## **FAULTS**

You can learn a lot about designing a circuit by looking at faulty circuits. We are now going to look at some badly designed circuits and see what NOT TO DO.

Here is a circuit of a 2-Transistor FM transmitter. It has a number of mistakes in the design. See <u>Voyager</u> project for a well-designed circuit.

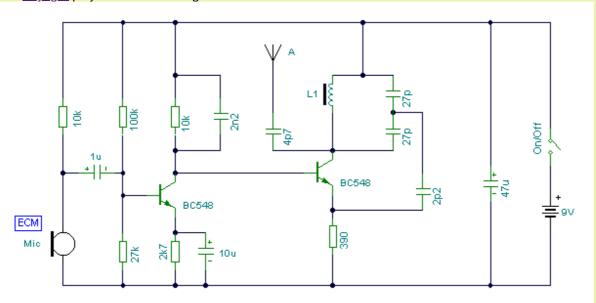
The load resistance for the microphone is too low. It will cause the microphone to have a very high gain and create a self-oscillating front-end.

The 1u coupling capacitor does not need to be higher than 22n. A ceramic is quite suitable for this.

The two stages should not be direct coupled. The oscillator stage should be self-biased so that it creates its own biasing. A "forced bias" does not allow the transistor to operate in its best set of parameters.

The tapping between the two 27p's gives a very small signal to the emitter. The 2p2 should tap off the collector. The parallel 27p's gives a value of 13p, whereas the capacitance across the inductor should be about 47p for the best "Q" for the tank circuit. No value has been given for L1. It should be 5 turns 0.25mm wire 3mm dia. The 47u across the battery is not needed. It should be replaced with 22n to tighten up the rails for the 100MHz oscillator.

Next we have an FM transmitter that looks to be well-designed. Apart from the complex circuit, there are a number of fundamentally incorrect features that make the circuit unreliable.

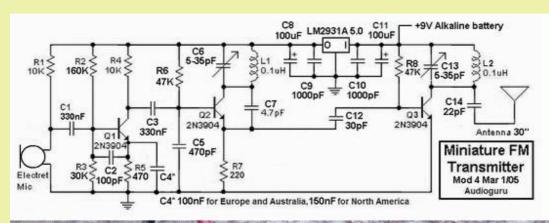
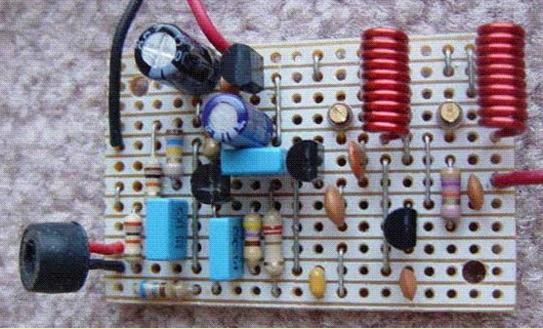
This type of circuit should NEVER be laid out on strip-board or any type of board that has extra conductive lines as they create "wires" that radiate signal and they can be so effective that all the signal is radiated and none is retained to keep the oscillator in a state of oscillation. That's why this type of layout can result in non-operation. The first item we will look at is the "Q" of the tank circuit.

In this case the 5-35p air trimmer will be set at about 20p for 90MHz while the energy stored in the 10 turn coil will be twice that needed. The 10 turn coil should be reduced to 5 turns and the capacitor should be increased to 39p - 47p. This will give the circuit a higher resultant output voltage.

With a low Q, the energy through C7 (4p7) will be very small.

We don't know how or where the tracks are cut on the "strip-board" but you can see some of the tracks will connect to the end of the 4p7 that goes to the emitter.

This track acts like a "transmission line" and since it is very wide, it will have a high value of radiation.

This means a certain amount of the energy delivered by the 4p7 will be lost to the surroundings and any handling of the project will cause drifting or it could come to a point where the oscillator fails when handled. In addition, some of the energy delivered by the 4p7 is being lost via the 30p coupling capacitor and the circuit may fail to work. We found 10p is needed.

The circuit may be successful as the oscillator transistor is being heavily driven via the 220R in the emitter. This may overcome the short-falls in the other design-concepts, but the 30p "take-off" should be connected to the collector of the oscillator stage as it will transfer a lot more energy.

The 1n across the power rails for the oscillator is insufficient to give good tightness (it should be 22n) and the placement of the components on the board is far too spread-out.

Since the output transistor is a buffer, the 22p on the antenna is not needed and simply reduces the range. The 10k resistor for the electret mic is too low for our high-sensitivity microphones. It should be 47k for 5v rail.

The 100u electrolytic across the battery is totally unnecessary as the current consumption is only a few milliamp. In addition, the 100u on the output of the regulator needs to be only 1u to 10u.

Our 9v Voyager circuit consumes 7-10mA for 800metre range. This circuit will consumes more than 25mA. One final point. The air trimmer should be in parallel with a capacitor (39p) so the trimmer is only adjusting a small amount of the total capacitance. This makes it easier to tune across the band and set the frequency.

Here is a circuit from CircuitsToday:

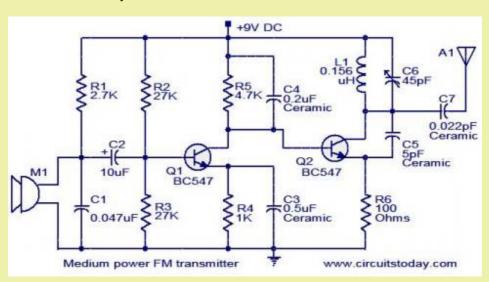
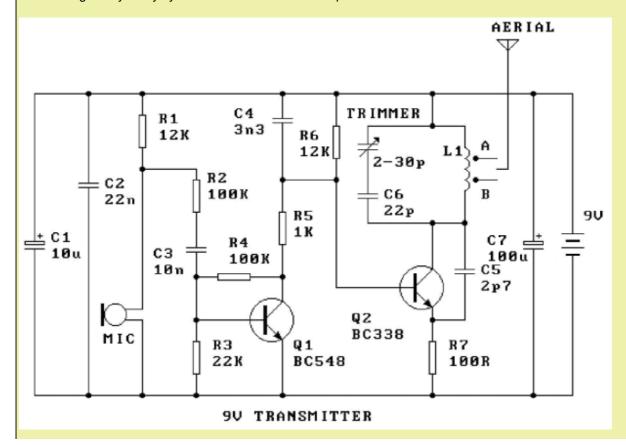
The Microphone symbol shows the old-fashioned mic for a telephone.

The 2k7 load for the microphone is too low. It will cause motor-boating. The load should be at least 47k.

The 47n across the microphone is not needed if the mic is biased correctly.

The 10u coupling to the base of the first transistor can be 22n.

The oscillator should be self-biased. This allows it to operate freely and maintain better stability.

The 100R in the emitter should be 560R as the BC547 can only handle a very low current at high frequency. The inductor should be specified as 5 turns of 0.5mm wire 3.5mm dia coil. The supply should be "decoupled" via a 22n capacitor.

The 200n capacitor on the base of the oscillator transistor is too high. It should be 1n.

The 22n on the antenna is not needed.

## **TELEPHONE BUG**

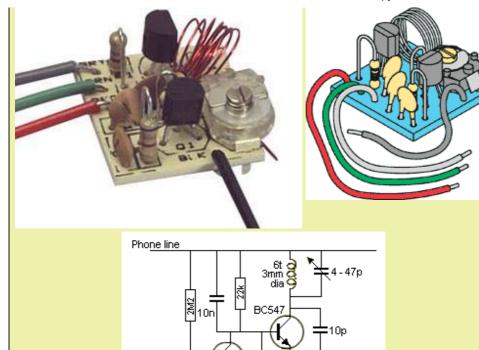
Look at the coil. A floppy coil like this is totally unsuitable as it will be "telephonic." This means it will vibrate when bumped and will even pick up sounds such as talking, music and footsteps and transmit them just like a microphone. I suggest you build this circuit and use 7 turns of thin wire on an 8-10mm pen and see how the coil picks up every sound in the room. Simply connect a 9v supply and the circuit will work. The coil should be 6t and 3mm diameter, using 0.5mm enamelled wire.

## **TINY BUG**

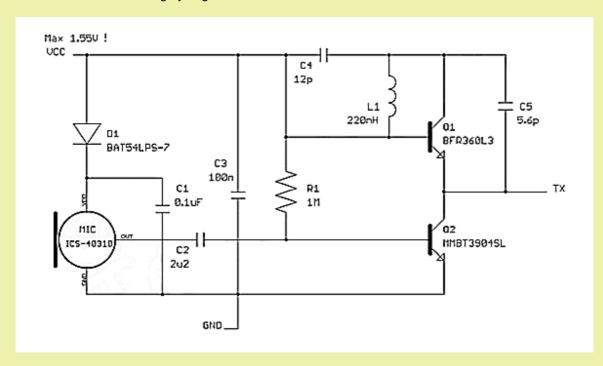
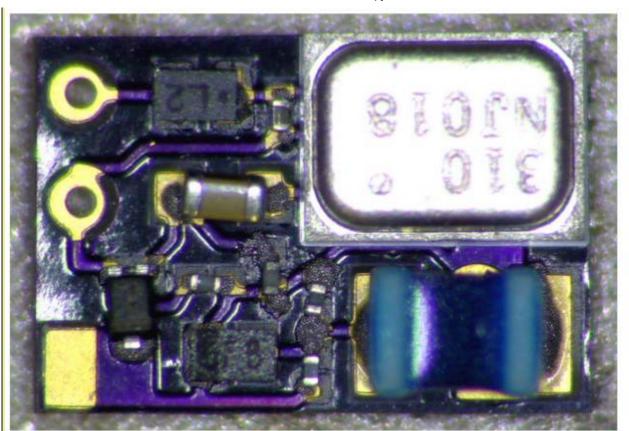
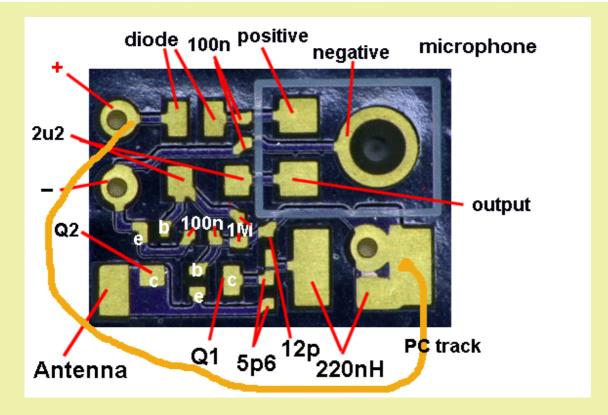
This circuit is very small but it does not have the arrangement of components that you would normally expect. The output transistor does not have a connection to the positive rail and the base does not have a bias resistor. Build it and see how much range you get.

This 3-transistor circuit has many faults.

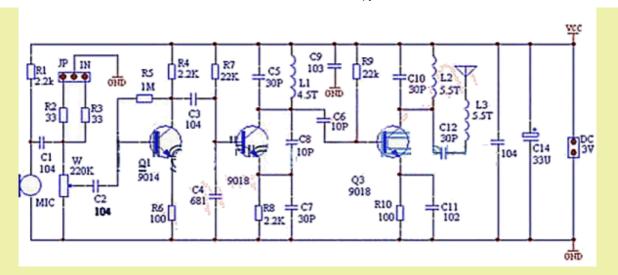
The 100n on the output of the microphone does nothing. It can be removed.

There is no reason to reduce the gain of the first stage to 22 when a volume control is on the input. The 100R can be removed.

The 30p across the 5.5 turn coil forms a tuned circuit and only does anything at a particular frequency.

The capacitor does nothing at the wrong frequency. It can be removed.

The inductor on the antenna does nothing in this case and can be removed.

The 100R on the output transistor reduces the output considerably.
